SUBJECT: Forwards response to NRC 831220 request for addl info re:
 TMI Item II.F.2, "Instrumentation for Detection of Inadequate
 Core Cooling."

Subject: Palo Verde Nuclear Generating Station (PVNGS)
Units 1, 2 and 3
Docket Nos. STN-50-528/529/530
File: 84-056-026; G.1.01.10

APS RESPONSE TO THE NRC
REQUEST FOR ADDITIONAL INFORMATION ON TMI-2
TASK ACTION PLAN II.F.2 FOR PALO VERDE
NUCLEAR GENERATING STATION
UNITS 1, 2, AND 3

* POSSIBLE IMPLEMENTATION IN FUTURE
DATA ACQUISITION AND DISPLAY SYSTEM
BLOCK DIAGRAM
Figure SD-1

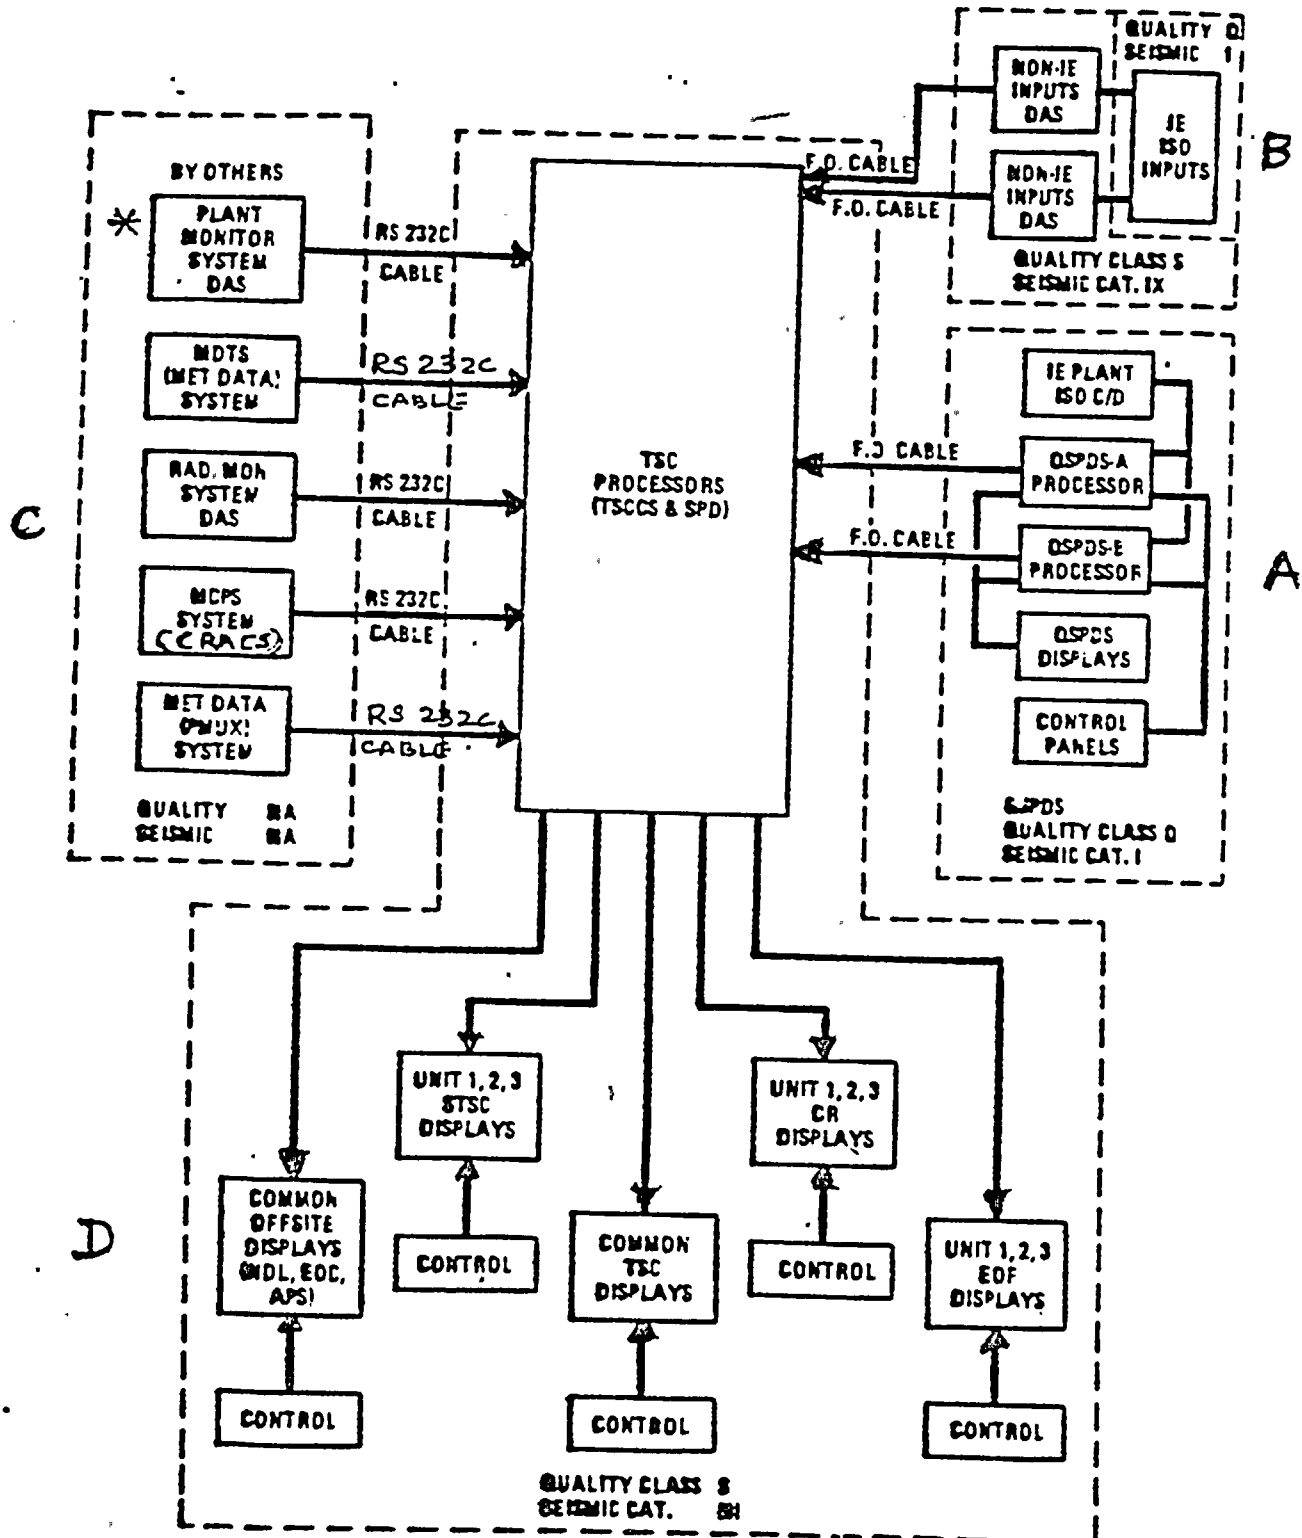
QUESTION: 1. Provide a functional and design description of the Emergency Response Facility Data Acquisition and Display System (ERFDADS) relative to the function and design of the Critical Function Monitoring System (CFMS) described in the CESSAR-80 submittal.

ERFDADS is a Non-Class IE System, very similar to CFMS, that provides all the above mentioned information. Figure (1) shows the block diagram of the ERFDADS System.

QUALIFIED SAFETY PARAMETER DISPLAY SYSTEM DIAGRAM

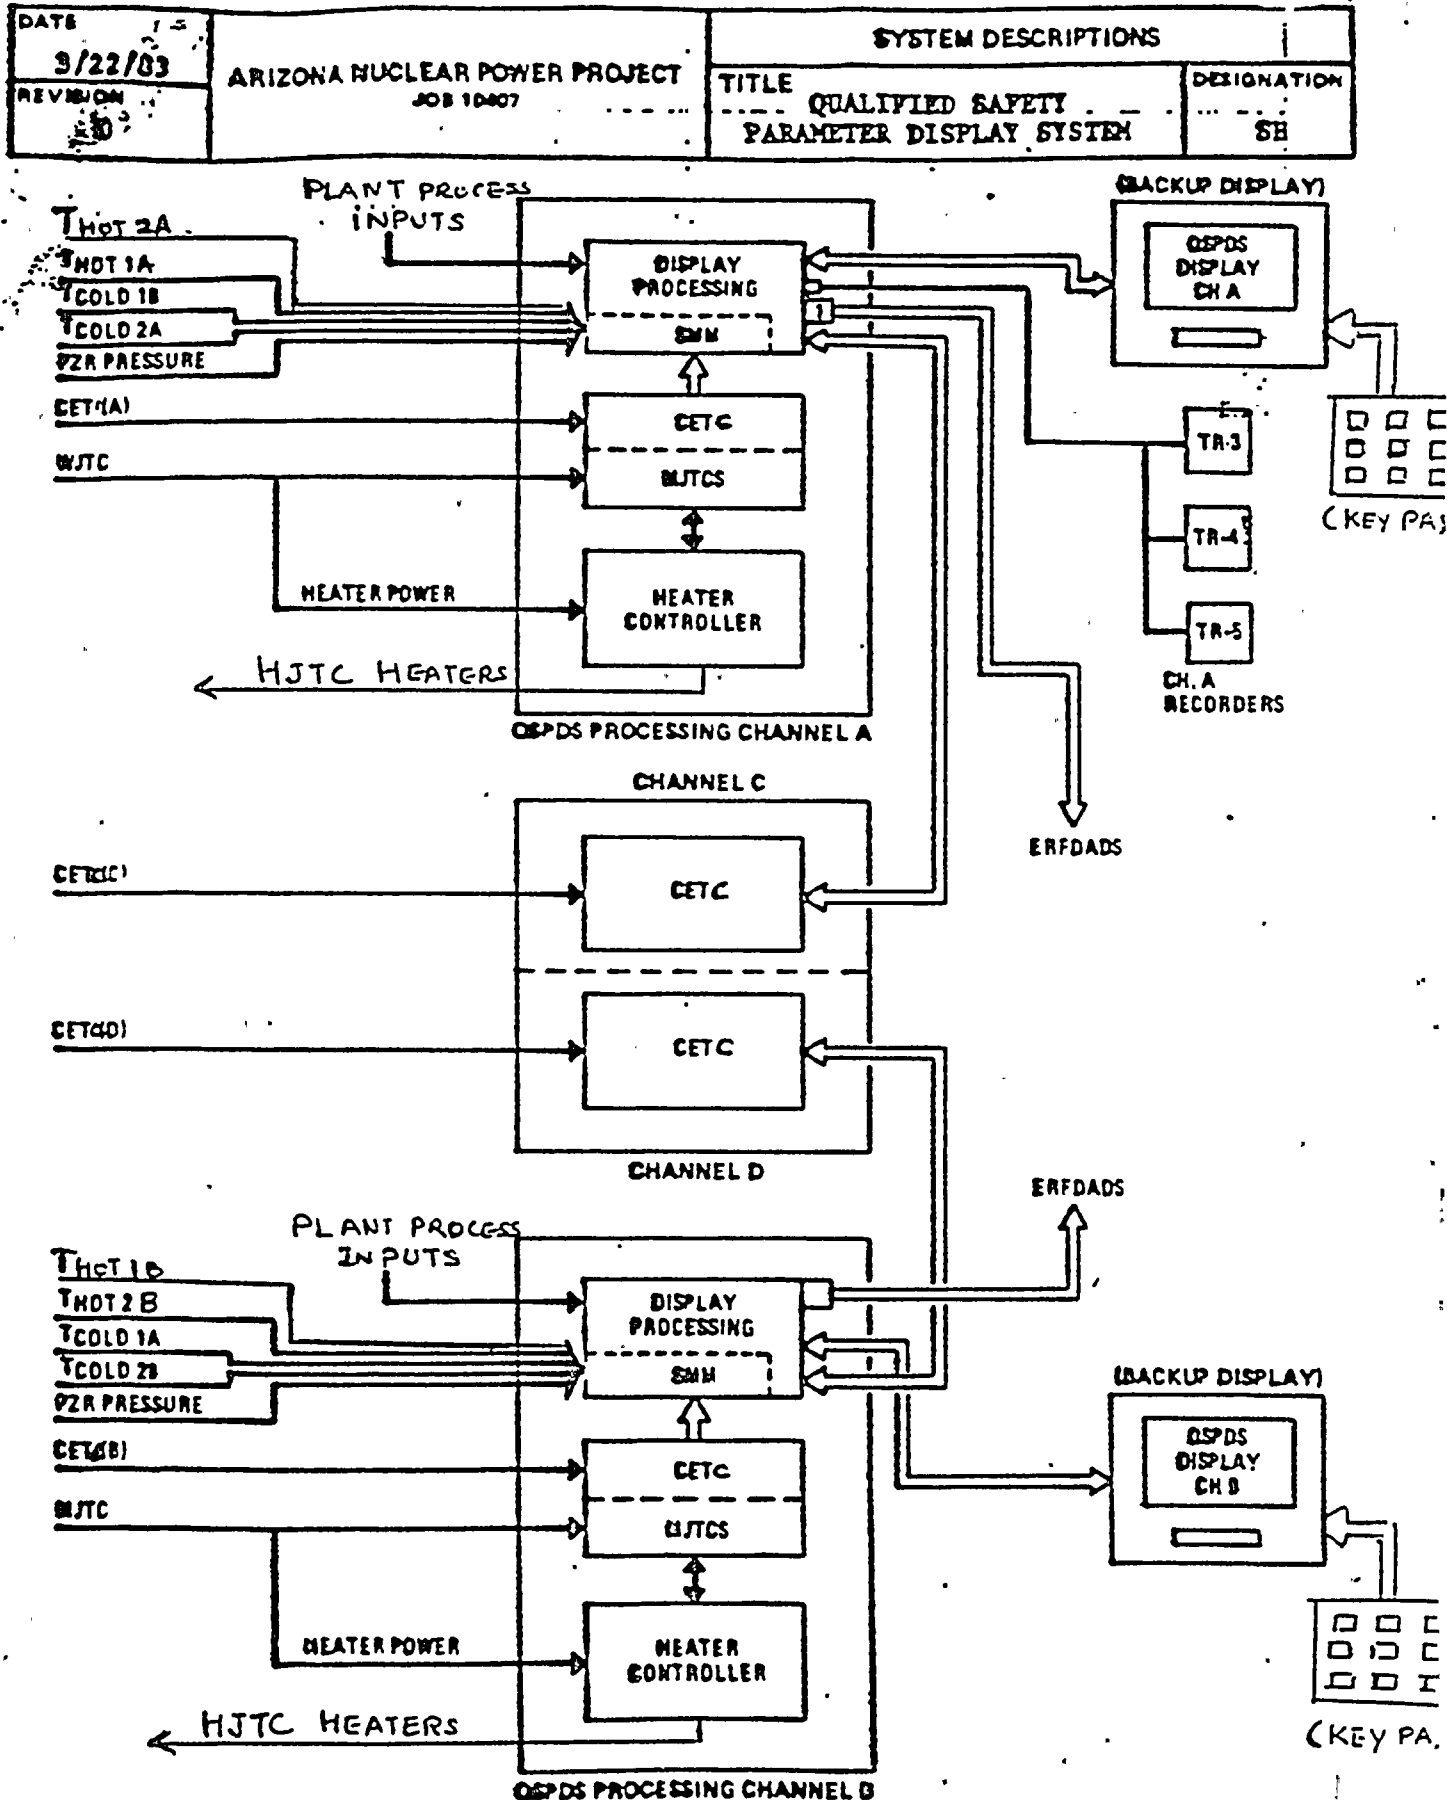
QUESTION 2. Provide a figure to show the Accident Monitoring System (AMS) including all of the components of the final Inadequate Core Cooling Instrumentation (ICCI) System which will clearly identify the primary and backup display system for Core Exit Thermocouples (CETs) and the location of the ICCI display system in the control room. Describe any deviation from the standard CESSAR-80 system design.

Figure (3) shows the block diagram of the QSPDS. It also identifies the primary and backup display systems.

FIGURE - 6
RVLMS Locations

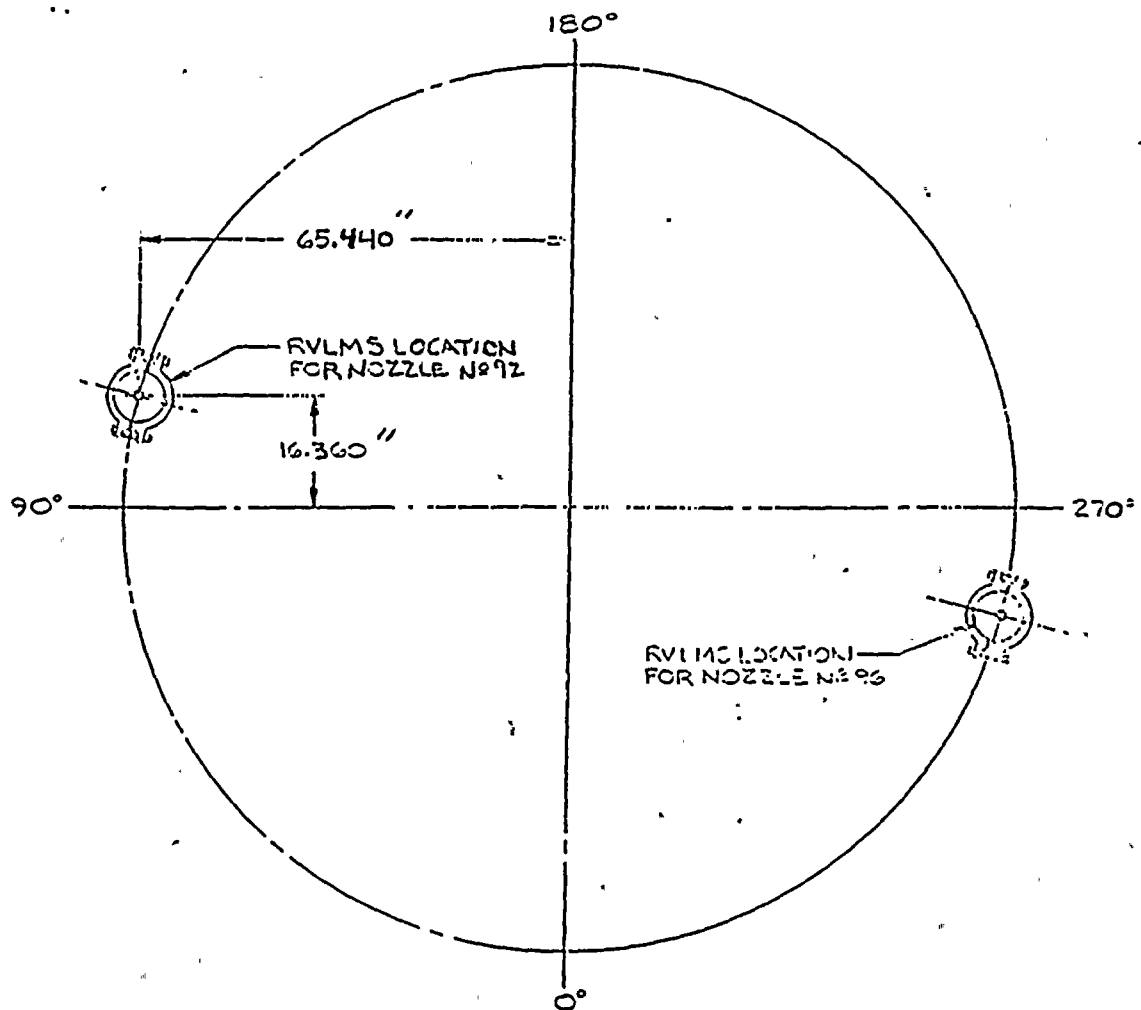
QUESTION 3. Describe locations of the Heated Junction Thermocouple (HJTC) sensors in the reactor vessel and identify any deviation from the standard CESSAR-80 system design.

RESPONSE: The HJTC design incorporates two separate probe assemblies which enter the reactor vessel through the two Reactor Vessel Level Monitoring System (RVLMS) nozzles located on the top of the reactor vessel head as shown in Figure (6).
